SUBJECT: Lake Pontchartrain, Louisiana and Vicinity Hurricane Protection
Project, - Memorandum of Meeting Orleans Parish Outfall Canal
Model Study Butterfly Control Valve

SUBJECT: Lake Pontchartrain, Louisiana and Vicinity Hurricane Protection
Project - Memorandum of Meeting Orleans Parish Outfall Canal
Model Study Butterfly Control Valve

SUBJECT: Model Study Meeting, Lake Pontchartrain, La. & Vicinity Hurricane Protection Project Orleans Parish Outfall Canals - Butterfly Control Valve Structures

HYDRAULIC SYSTEM OPERATION

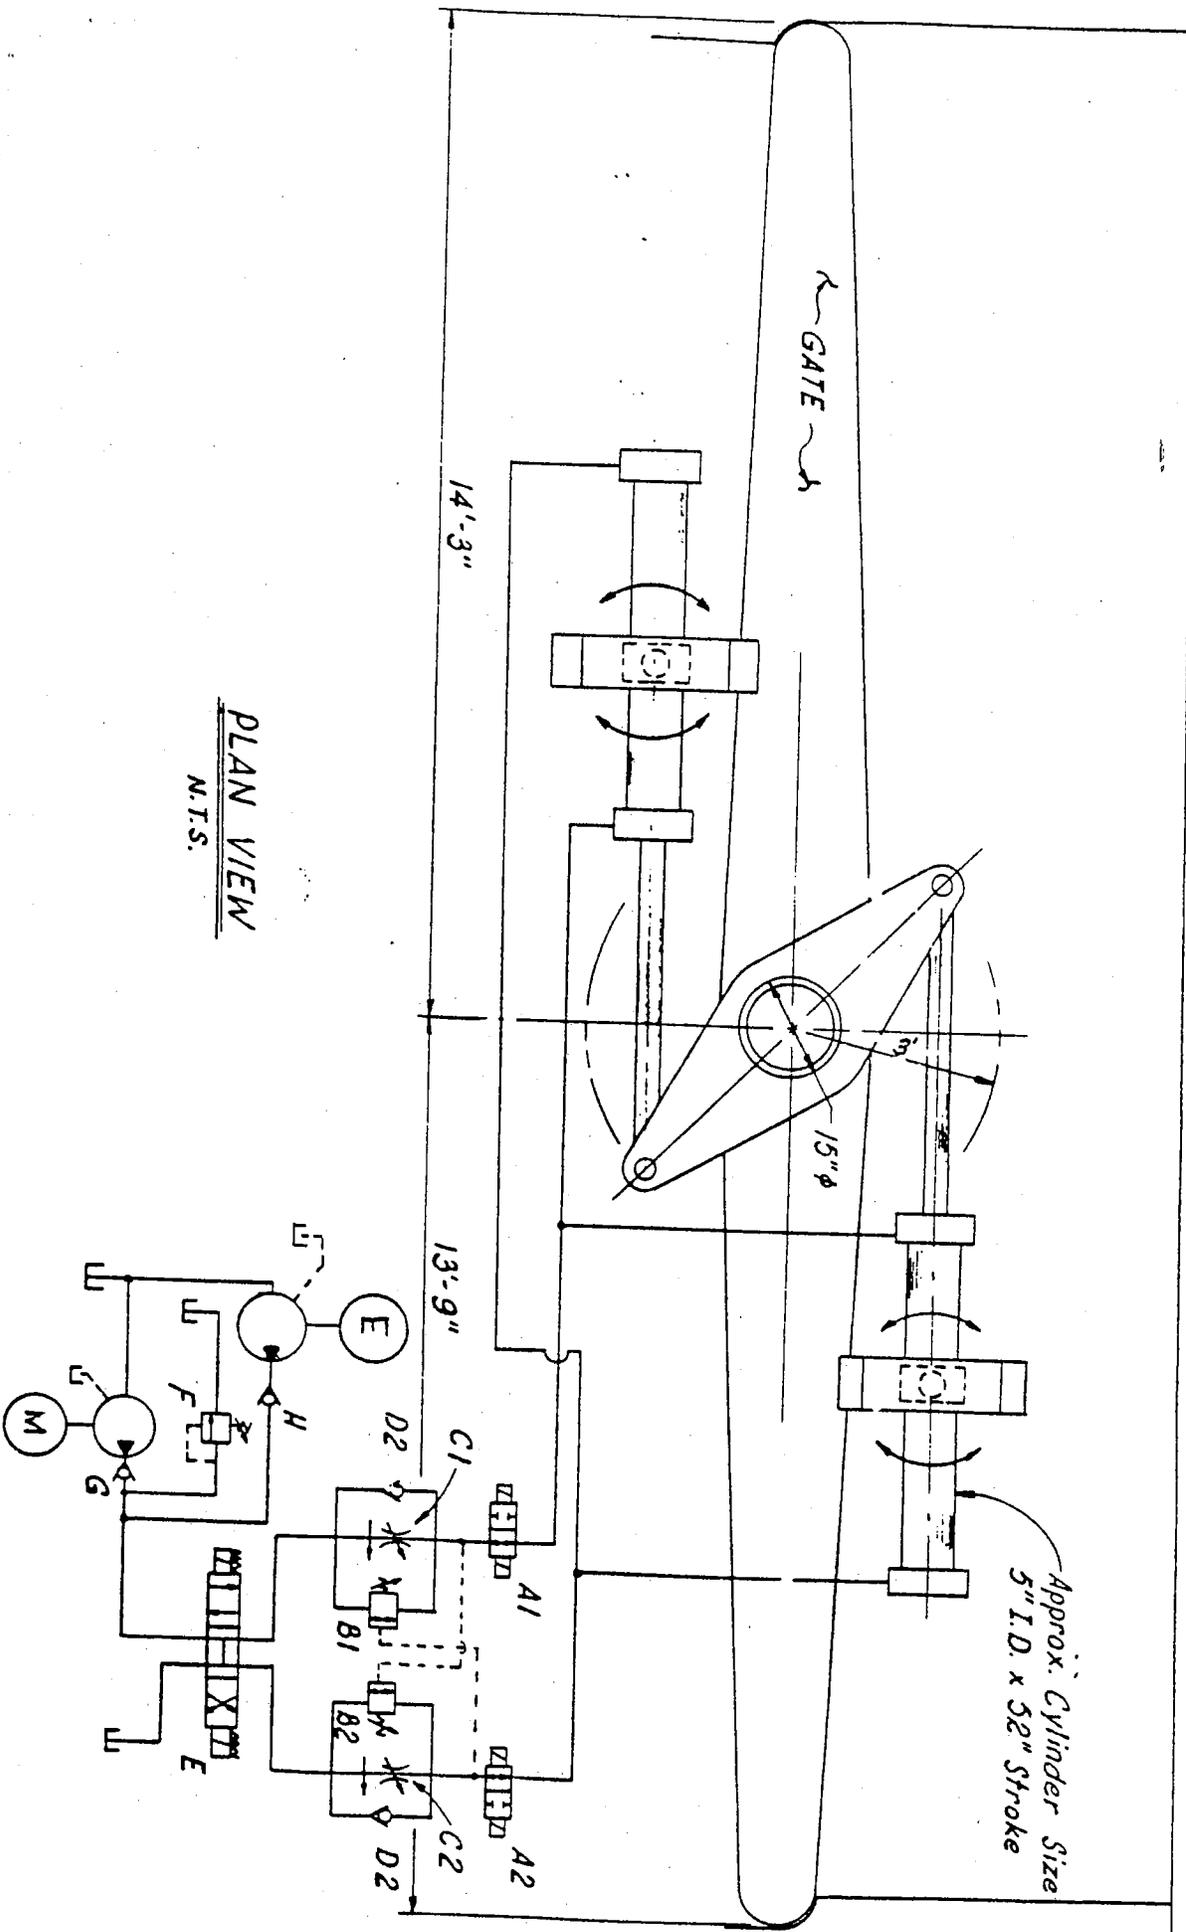
Mr. Strecker explained the proposed hydraulic operating system that could be used to override the valve's self-activating mode of operation. The hydraulic system also serves as a dampening device which regulates the rate of opening and closing of the valve. An optimum rate of opening and closing is to be established based on an integrated response of the valves to pumping, canal currents and wave conditions which are to be examined in the model. Inclosure 4 gives a schematic detail of the hydraulic system's internal valve arrangement and operating sequence.

Meeting attendants agreed that at least one of the gates for the model should be built to simulate the dampening characteristics of this system, i.e., opening and closing rates.
